P05-016 – Opus Gateway Office

- REQUEST:
- A. **Environmental Determination:** Final EIR, State Clearinghouse #2000072035;
 - B. **Schematic Plan Amendment** to depict the proposed project within the Promenade at Natomas PUD;
 - C. **Special Permit** to construct four office buildings (for a total of 590,000 square feet), a three-story parking structure, and a 350 space park-and-ride lot in the EC-50-PUD and SC-PUD zone.

LOCATION: Northeast Corner of Truxel Road and Interstate-80
APN: 225-0160-086
Council District 1

Schematic Site Plan

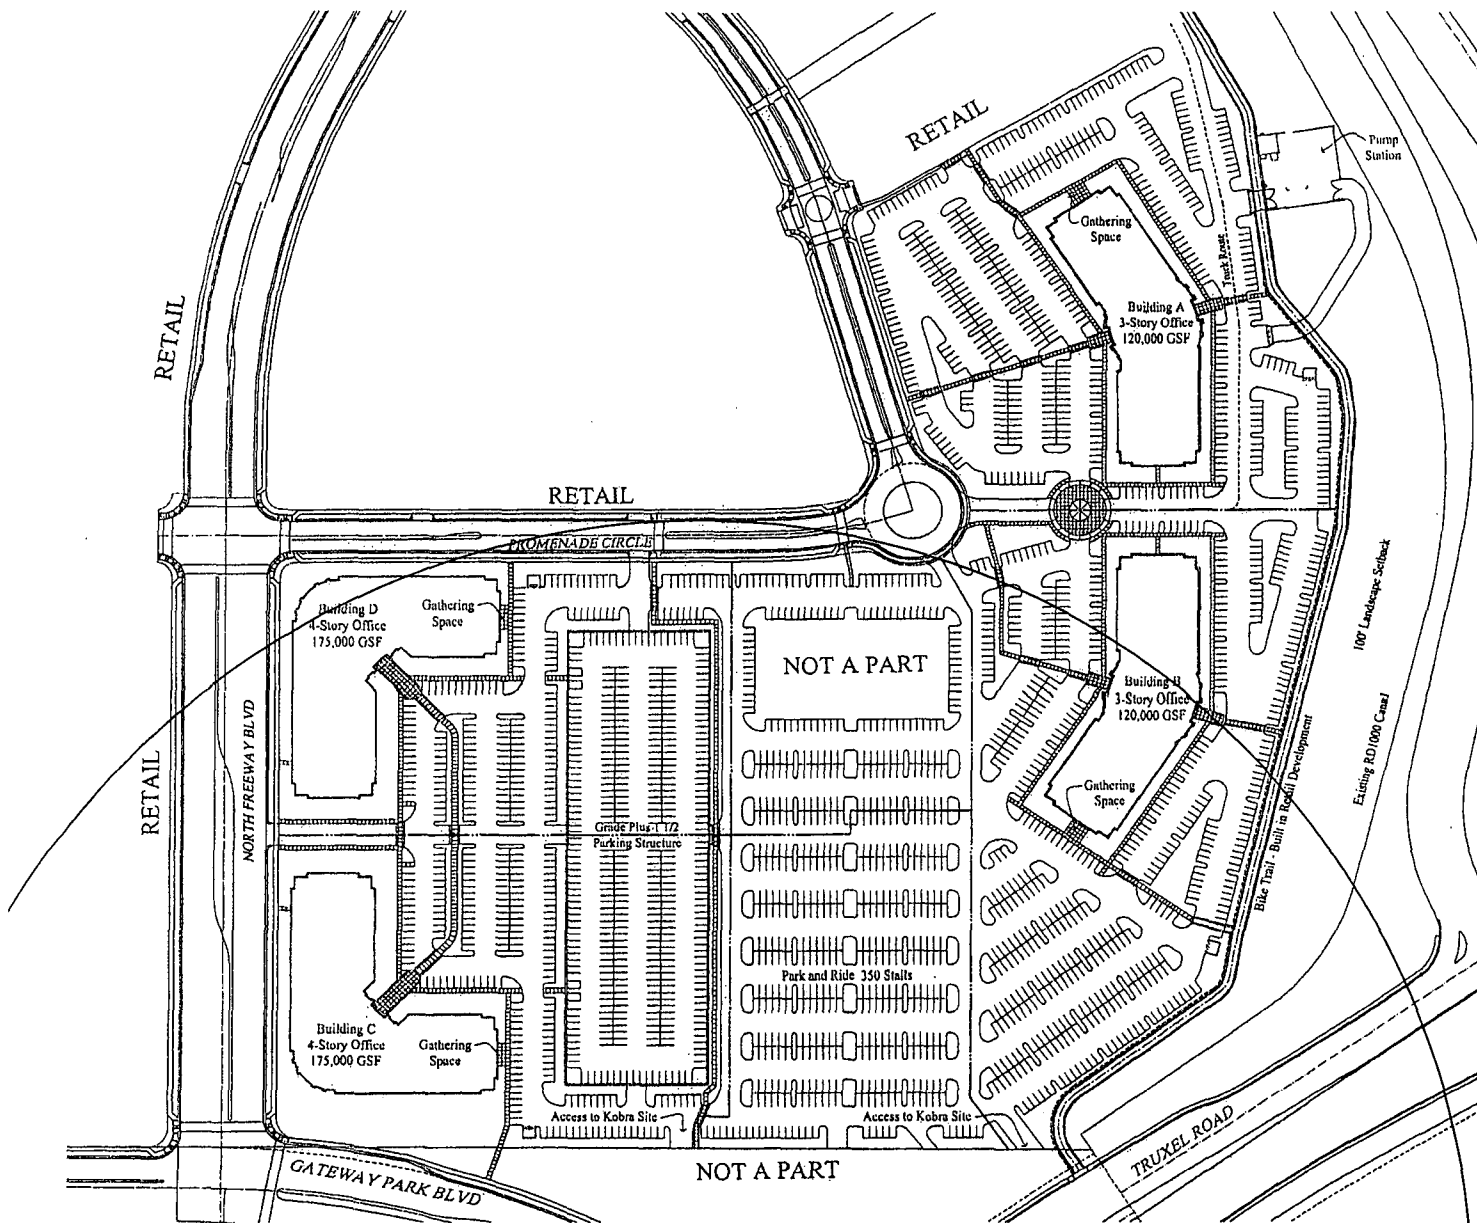
Additionally, the proposed office use is transit-friendly in nature and has the potential to result in an increase in transit ridership. However, the office building proposed to be located further east of the site, near the Pump Station (Building A), is not located within a convenient walking distance radius of the future light rail station. RT would prefer that Building B be moved closer to Truxel Road so that Building A can then be situated closer and within walking distance of the future light rail station. The parking spaces can be moved east of the two buildings. Additionally, a primary entrance into Building B can be located on the southern edge of

the building for ease of access into the building. This design will encourage the use of transit by future office occupants.

T.G.I. FRIDAY'S & SONIC RESTAURANTS
 1 RUXEL ROAD AND GATEWAY PARK BLVD.
 SACRAMENTO, CALIFORNIA

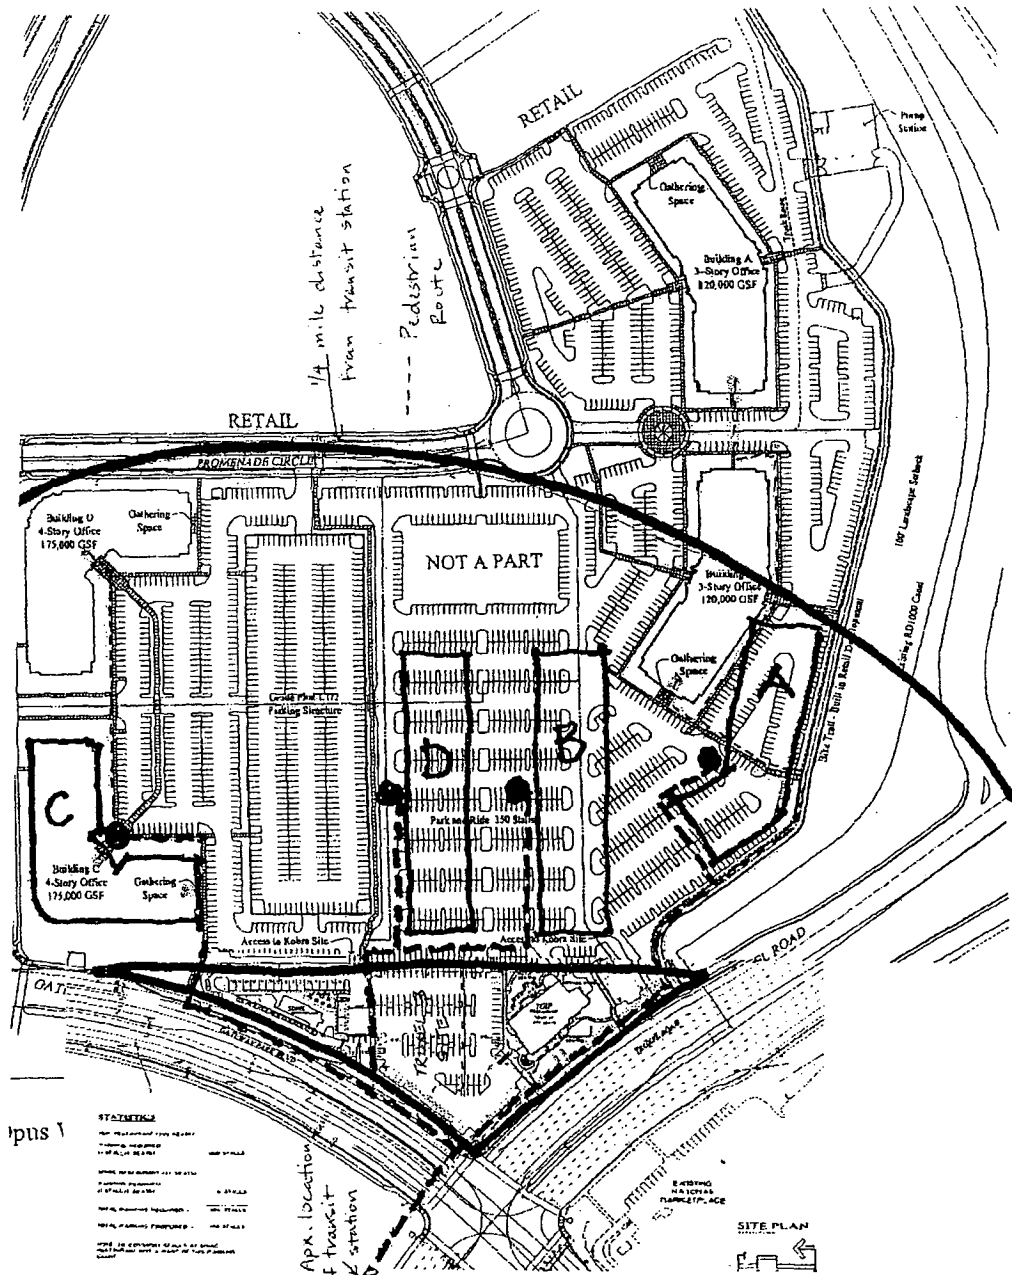
The design of the proposed site plan makes a statement that most of the project's users will be arriving by automobile. The buildings are placed along the north and south edges of the site which tends to maximize the walking distance from the transit station to the building entrances. As proposed, walking distances (dashed line labeled "Pedestrian Route" on site plan attached to an e-mail sent by you today) are approximately as listed below.

Building A	2,167 feet = .41 miles
Building B	1,693 feet = .32 miles
Building C	1,138 feet = .22 miles
Building D	1,548 feet = .29 miles

The proposed location of the buildings on the site should be adjusted to favor pedestrian access to the light rail station. If the office buildings were placed along the west and southwest edges of the site, maximum walking distances of .22 miles could be achieved from all building entrances and the project would present a much more visible image to the transit station. For a possible alternative, see attached site plan. Future effectiveness of the transit system is dependent on appropriate density in close proximity to the stations.

Staff Response: Staff recognizes that there are competing interests on this project site and believes that the proposed arrangement of the office buildings maximizes the linkages between the light rail station, the park-and-ride lot, the office buildings, the public streets, and the approved retail uses within the PUD. While there does appear to be a lot of parking stalls on this site, it is unclear if the letter recognizes that the 350 spaces closest to the proposed Light Rail Transit station are to be designated as park-and-ride spaces, intended to service the station. The effectiveness of the transit station depends upon the proximity of the office buildings, but also the park-and-ride spaces. The effectiveness of the Promenade at Natomas PUD to provide a well integrated mix of land uses is affected by the proximity of those land uses, therefore staff does not support relocating all of the office space to the west side of the project site, but rather prefers an arrangement that balances the needs of the light rail system with the need to locate office space as conveniently as possible to the retail and pedestrian amenities that this site provides (the pedestrian promenade area). The applicant continues to work with the property owner to the west to ensure that there will be direct, well-designed pedestrian connections to this project site.
